Non-Technical Summary Normal Variation December 2023

The proposed changes to the environmental permit EPR/WP3633KH include the following aspects:

H1 Assessment findings

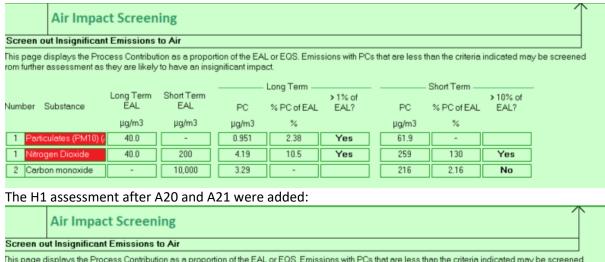
The H1 assessment was modelled using the average of the last five readings where available or all readings if less than 5 available as the long term concentrations with the highest individual reading for the short term concentration for emission points A1 to A19. The proposed maximum permitted limits for A1-7 were used as potential maximums for both long term and short term concentrations for A20 and A21.

The Assessment shows an increase in particulates as a result of the new filter additions but these remain under 50% of the long term PC of EAL. It is anticipated based on performance of other filters on site that the in use measured values are likely to be significantly lower than these modelled values (the average for all other particulate readings is 1.53 mg/m³ with a highest reading of 4.9 mg/m³ with 20mg/m³ being used for this modelling exercise).

There are no changes to any of the systems which are evaluated for NO or CO.

As H1 has shown that these changes are not significant and it is not proposed to do any further air dispersion modelling to assess the impact.
